Urban Design Expert Evidence

Planning Scheme Amendment c433
Pakington Street Urban Design Frameworks

Amendment No.	C433ggee
Prepared for	City of Greater Geelong
Instructed by	Harwood Andrews
Issued	10/02/26
Site Visit	13.01.2026, 7.12.2025 & 29.02.2024

Figure 19: Figure 2: Future park interface (Schedule 56 to Clause 43.02 Gordon Avenue Precinct, p. 3)

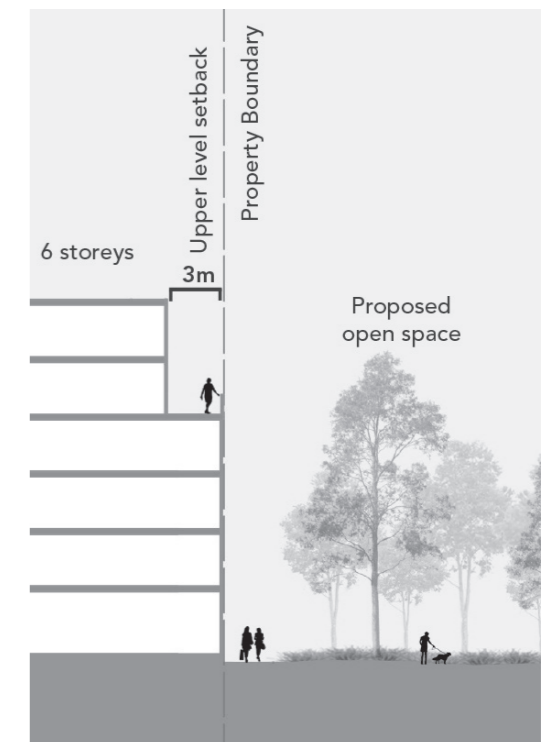
93. The Future Park Interface also raises concern. It describes a zero-metre setback along three sides, with the western interface (as shown in the UDF) fronting a laneway. It is unclear what agreements or assumptions underpin this outcome; however, a zero-metre setback is not considered a preferred urban design response. A setback from the future property boundary would allow for a landscape transition between the park interface and building entrances if developed for residential use (as implied by the balconies shown and the proposed zoning). Alternatively, if a commercial or retail use is envisaged, a setback would enable on-park activation and trading.

- Ensure alignment between UDF and DDO in labelling, metrics, and diagrams.
- Correct UDF diagrams so setbacks are measured consistently to building edges, not balconies.
- Reconsider the Future Park Interface to allow for a landscape transition zone between public parkland and private development (approx. 2 m recommended).
- Undertake built form testing to justify a 5 m ground-level setback plus a 5 m upper-level setback above two storeys.
- Clarify whether setbacks are measured from building edges or balcony edges and ensure consistency across all diagrams and controls.
- Resolve inconsistencies between UDF text, diagrams, and DDO provisions.

Figure 23: Figure 6: Preferred side separation for buildings built to boundary (Schedule 56 to Clause 43.02 Gordon Avenue Precinct, p. 4)

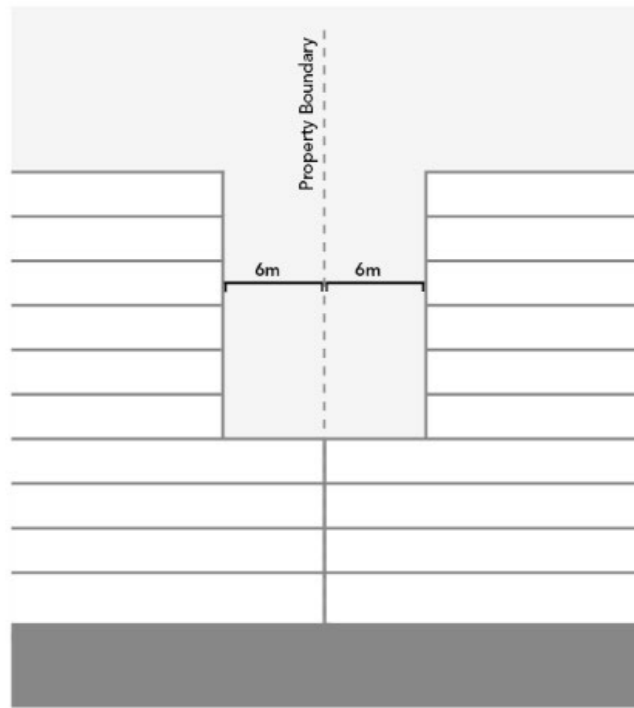
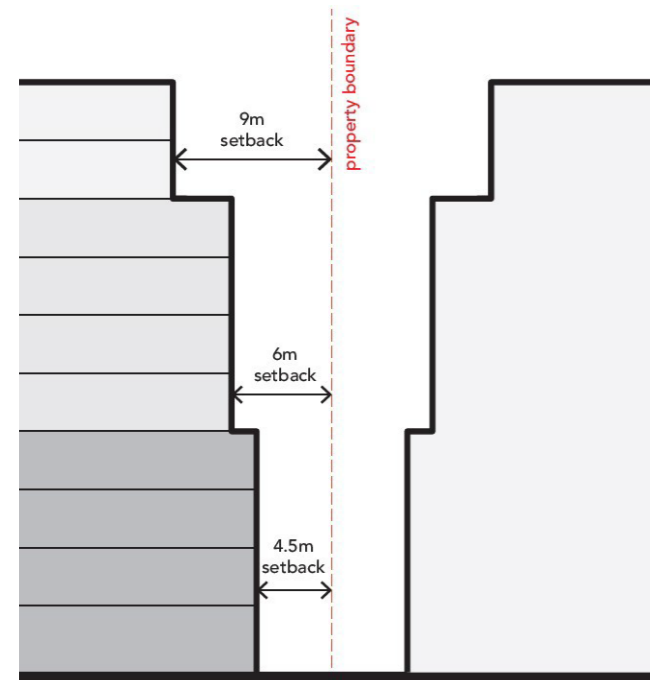
- Clarify how building separation and side setback requirements apply where podium or street wall heights exceed four storeys.
 - Reconsider and/or clearly justify upper-level side setback and separation distances, particularly where they exceed comparable controls in other planning schemes.

- Excessive or untested separation distances may unnecessarily constrain development potential and undermine the intent of the controls.
106. Building design

Figure 25: Map 2 to Schedule 56 to Clause 43.02 (site coverage, p. 11)

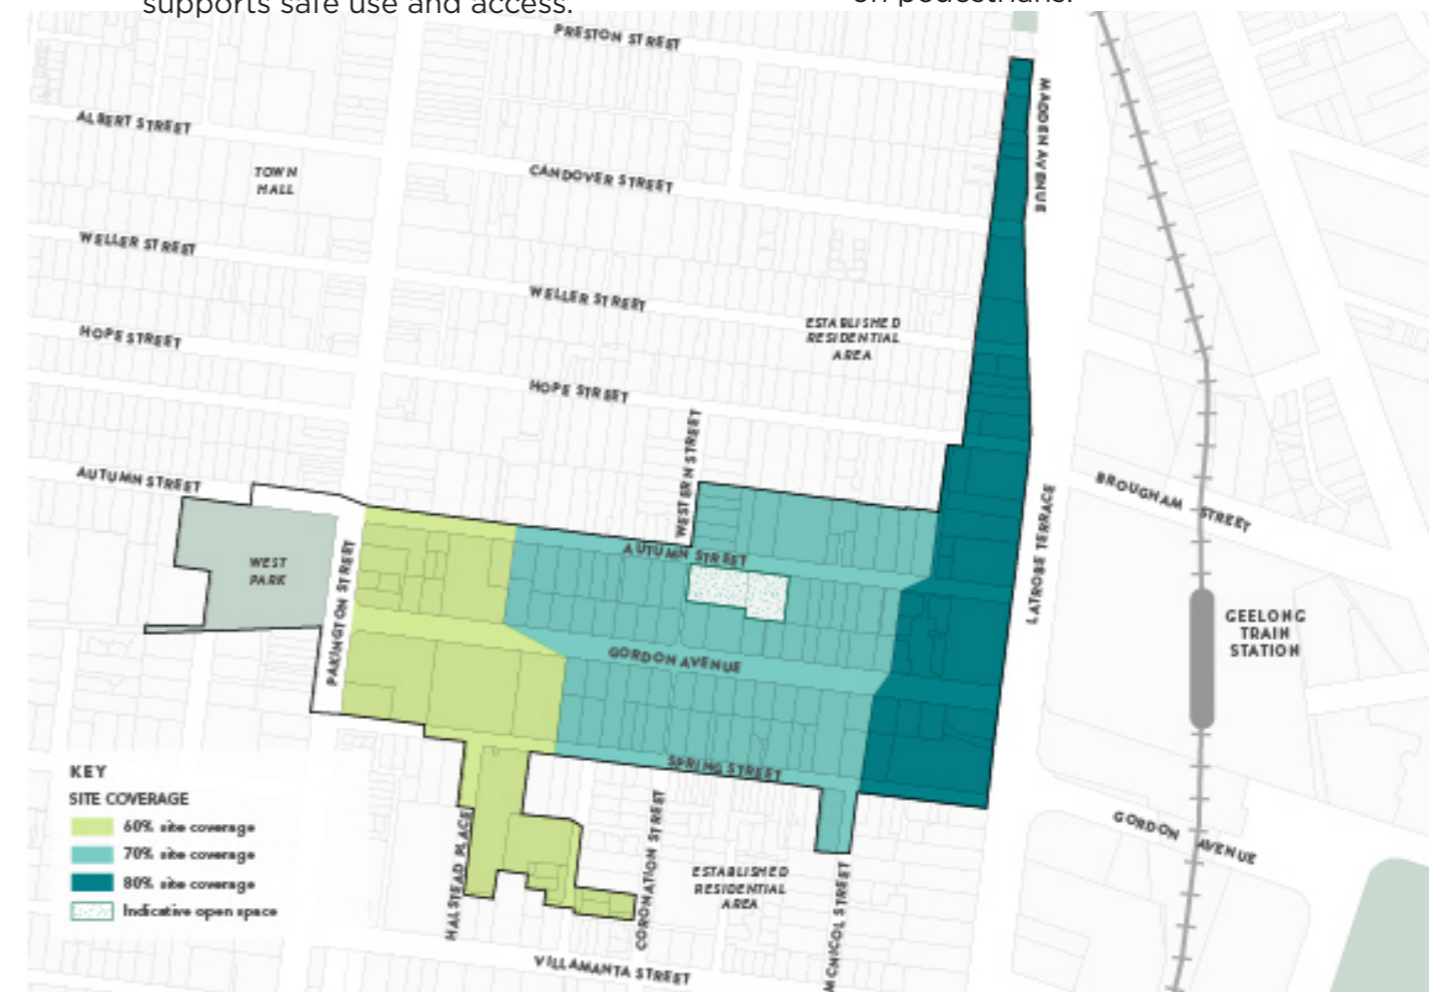
- Provide further detail on the preferred location and treatment of undeveloped land, particularly along Latrobe Terrace, to clarify intended site coverage outcomes.

Figure 33: Figure 8: Open space interface (Figure 10 p.42 Pakington North Urban Design UDF 2024)

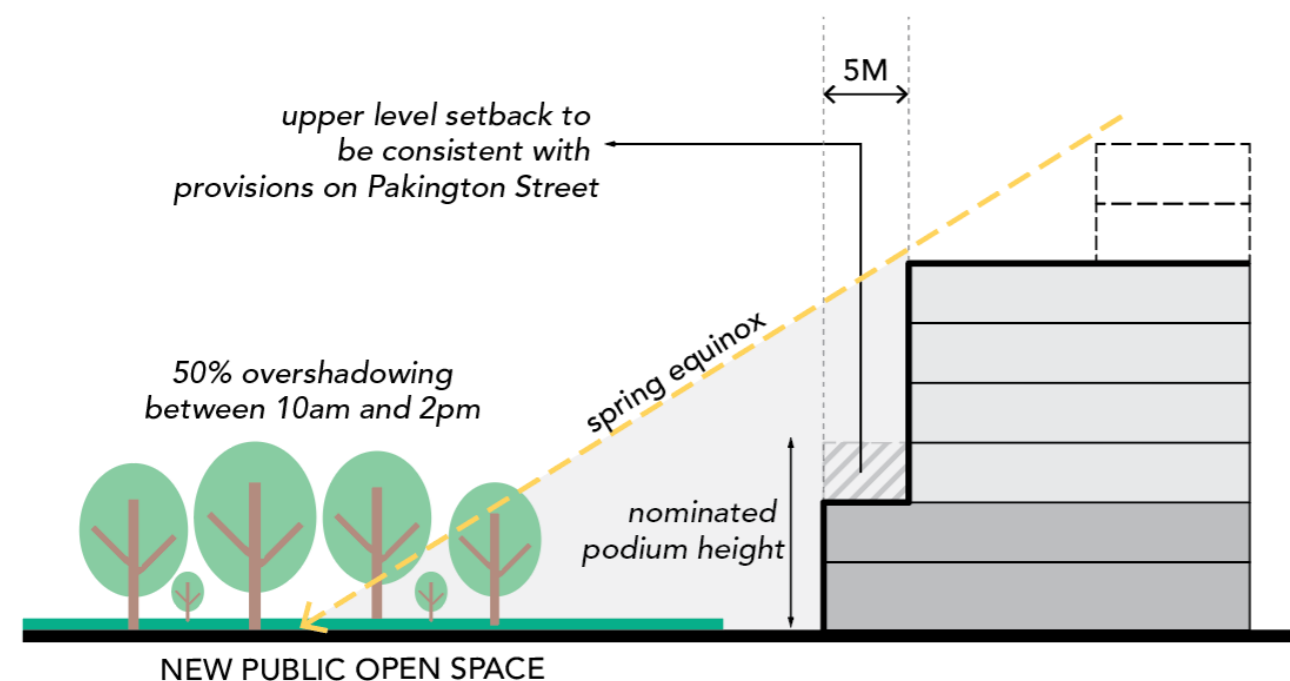
146. The open space interface diagram (Figure 8) states: “50% overshadowing between 11am and 2pm.” This wording may be difficult to interpret - for example, it could be read as open space should receive 50% overshadowing during that time.

- Revise the wording “50% overshadowing between 11am and 2pm” to “maximum 50% of open space to be overshadowed between 11am-2pm at the winter solstice”.

Figure 36: Map 3 to Schedule 57 to clause 43.02 (site coverage, p. 14)

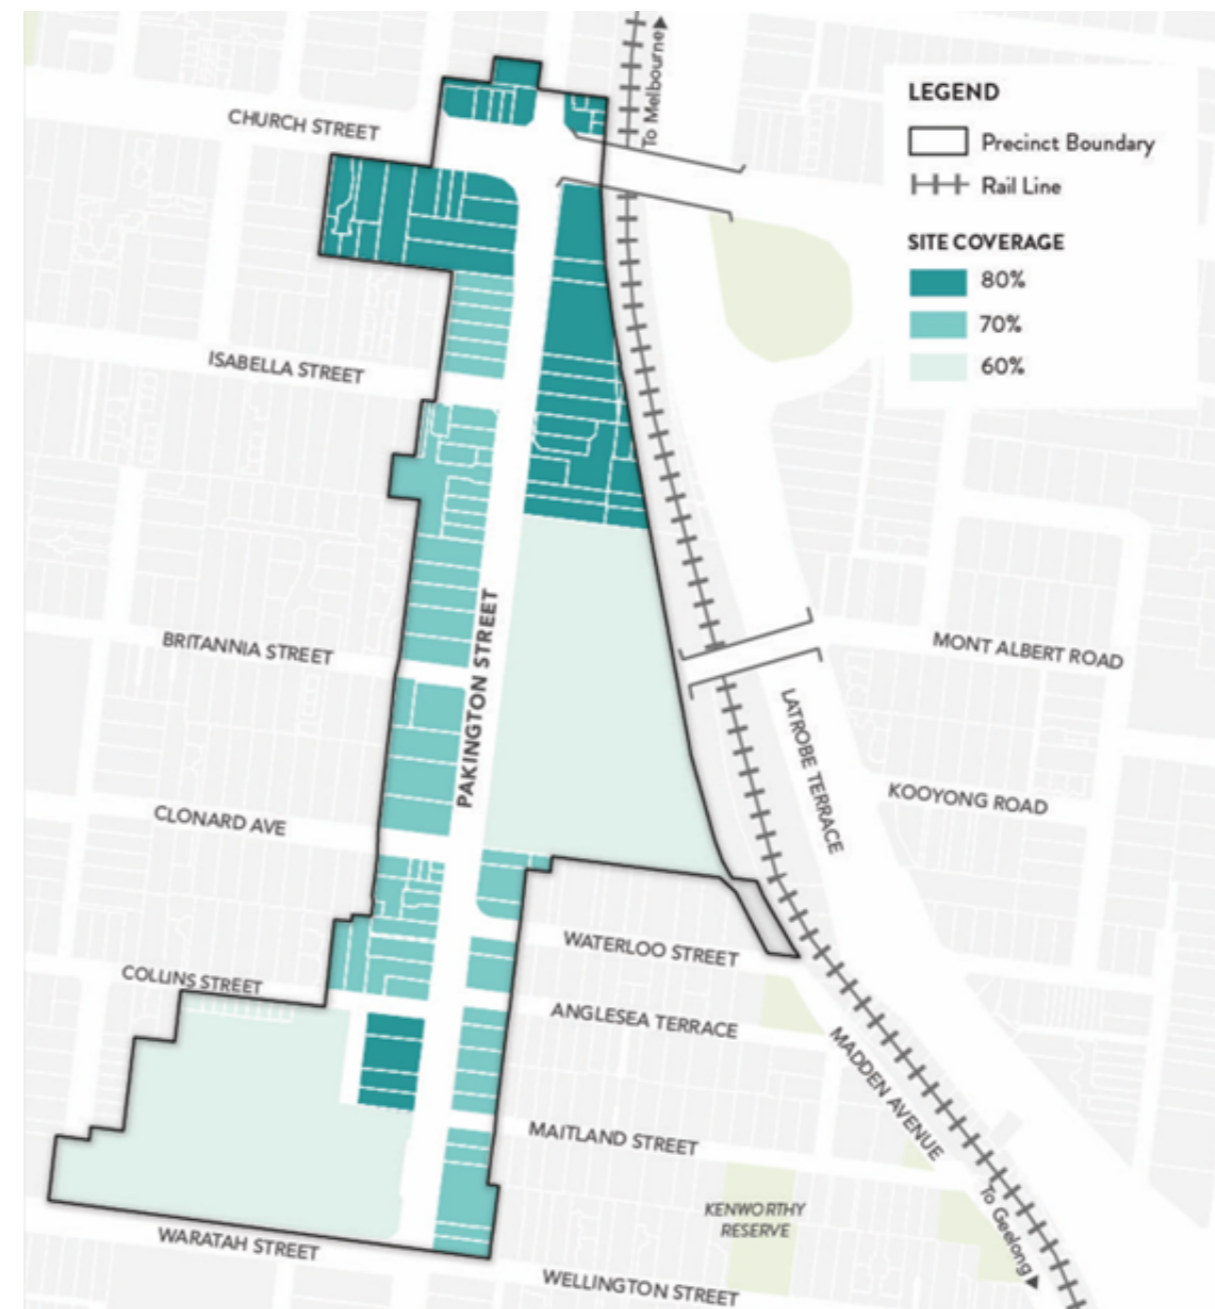
167. The DDO reflects the UDF’s differentiated site coverage approach, which can be summarised as: 60% site coverage for areas adjoining proposed open spaces and public plazas (including the Rail Sidings site and Waratah Street), 70% across much of the Pakington Street Retail Core, and 80% at the Church Street Junction, a less sensitive interface. These controls are supported, as they respond appropriately to context, support landscape amenity, and enable a diversity of built form typologies. However, additional guidance is needed to clarify how the non-built portion of sites is intended to function and be located. For example, within the Woolworths Strategic Site, it is unclear whether the 20% undeveloped area is intended to be consolidated along Waratah Street (noting the 3-metre built form setback) or whether its location is flexible. Without clearer direction, site coverage controls may result in fragmented or unintended open space outcomes.

168. I recommend the following:
- Provide further detail on the site coverage outcomes sought for the Woolworths Strategic Site and the Rail Sidings Strategic Site.
 - Clearly articulate the preferred location and function of non-built areas within these sites.
 - Clarify whether the 20% undeveloped land within the Woolworths Strategic Site is intended to front Waratah Street or be more flexibly located and provide equivalent clarification for the Rail Sidings Strategic Site.
